RHODE ISLAND DEPARTMENT OF TRANSPORTATION

RHODE ISLAND CONTRACT NO.2013-CT-060

**Contract 3 – State Traffic Commission**

NOTICE TO PROSPECTIVE BIDDERS

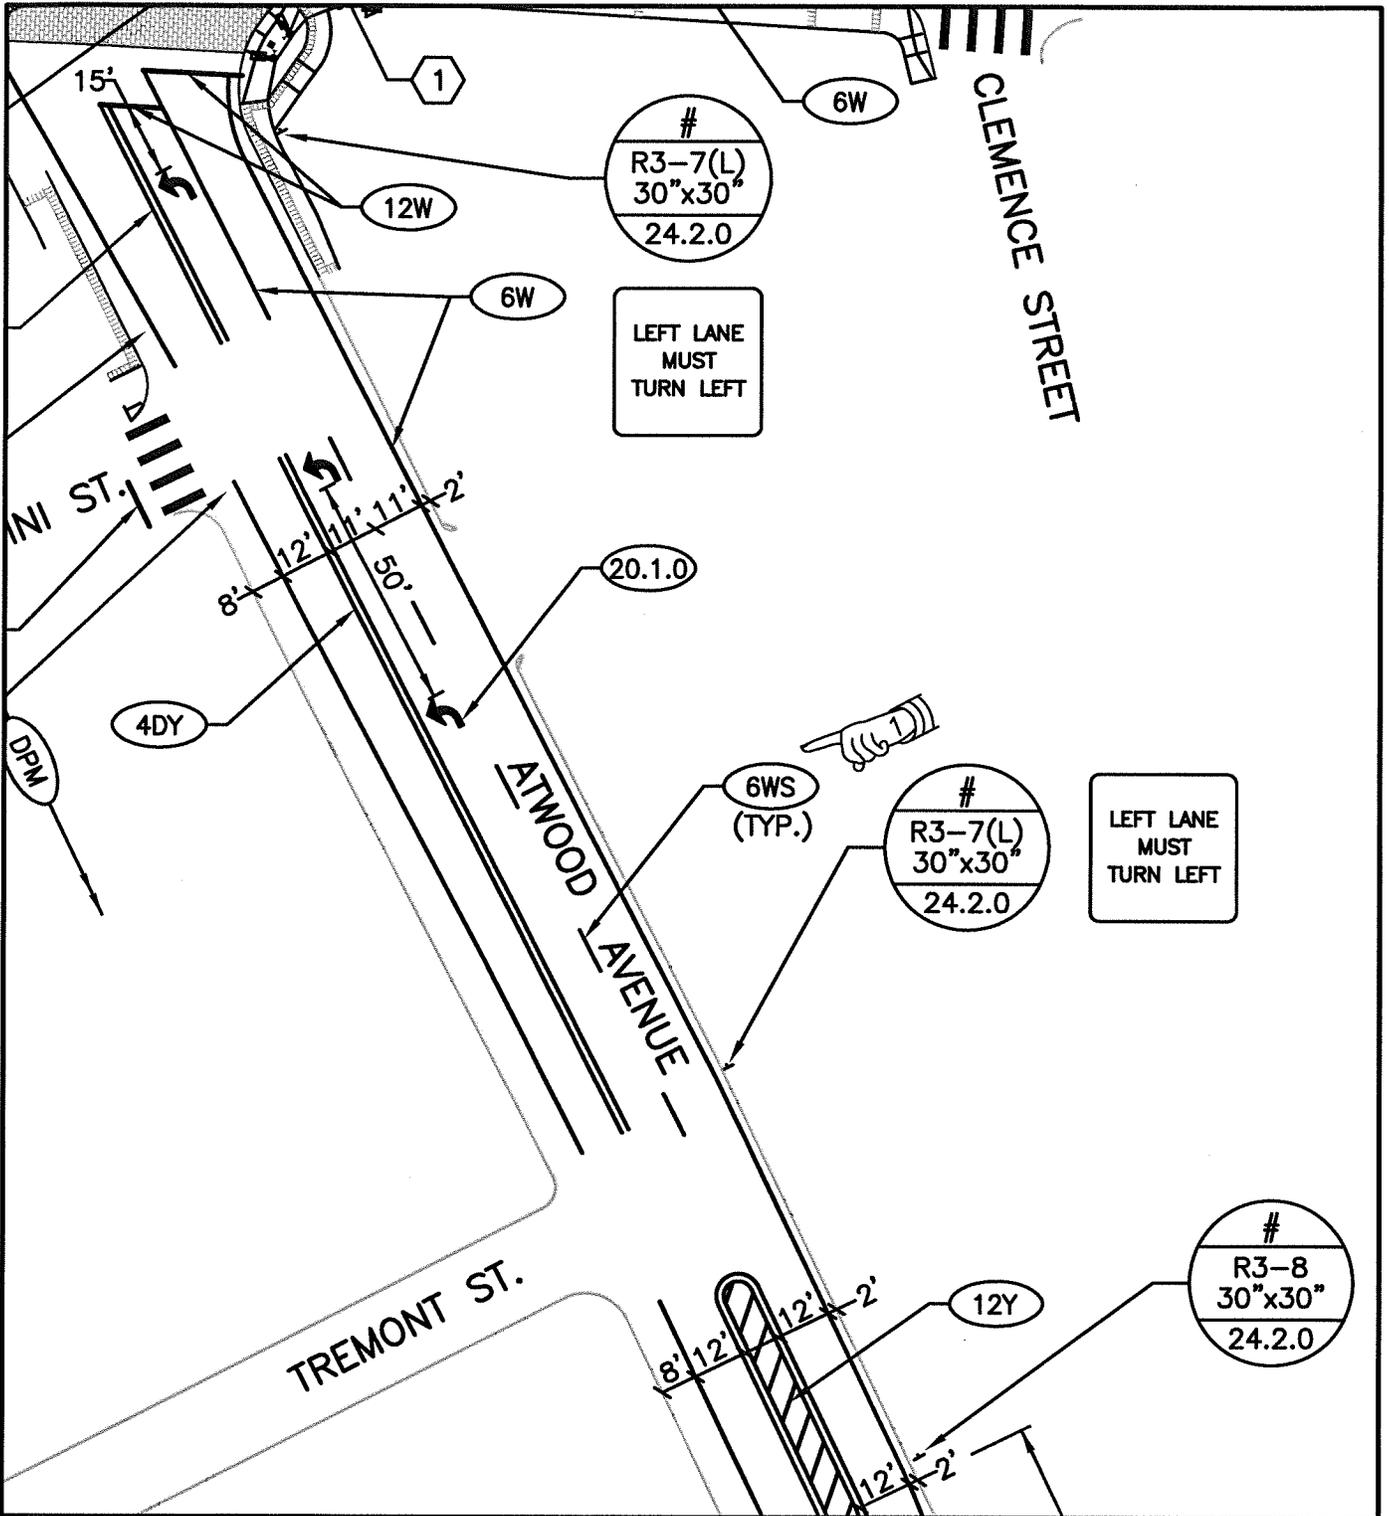
Delete pages JS-44 and JS-45 in their entirety and replace them with revised pages JS-44(R-1) and JS-45(R-1) attached to this Addendum No. 2. The Basis of Payment has been revised.
